#### ADDENDUM NO. 1.0

Project: Project #: 0117- 464

Father Keith B. Kenny K -8 Telecenter Upgrade Project

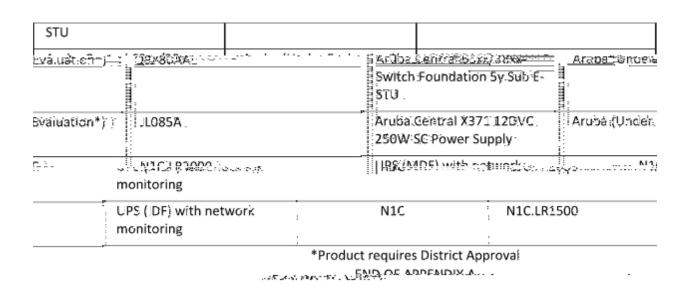
<u>Question:</u> Please confirm that the district wants to purchase a TCU3100SW Stream to SIP license for this project. Typically, the district does not use this feature. The TCU3100SW Stream to SIP license allows SIP extensions to be included in paging zones in Telecenter U. This feature provides for audio to be sent to SIP phones or other SIP-enabled devices as part of zones in emergencies, live and prerecorded pages, and bell schedules.

The District does not want to purchase SIP license for this project.
